## SERVICE BULLETIN

<b>Reference number:</b>	SB-01-1125	<b>Issued:</b> 20 August, 2018
<b>Subject:</b>	Touch pad cover	
<b>Model(s):</b>	Vantage 19MY	
<b>VIN Range:</b>	N00082 to N00289	
<b>Applicable to:</b>	All Dealers	
<b>Distribute to:</b>	<b>After Sales Manager</b> <b>Executive Manager</b> <b>Service Manager</b> <b>Sales Manager</b>	<b>Warranty Staff</b> <b>Technician(s)</b> <b>Parts Staff</b>

Figure 6

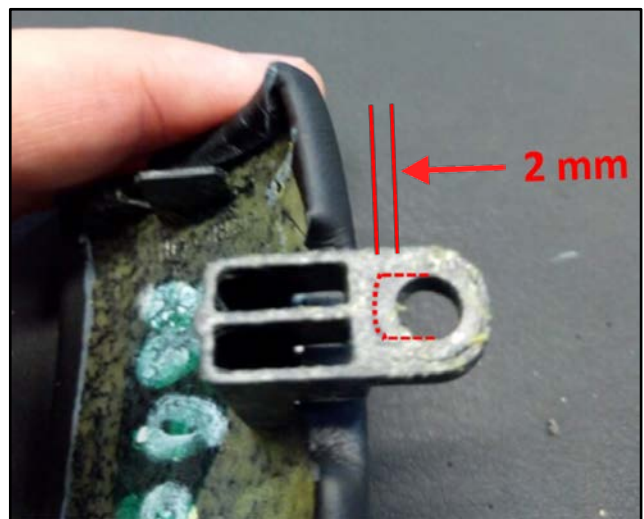
6. Extend the screw hole in the touch pad cover by 2 mm to make a slot (refer to Figure 6).
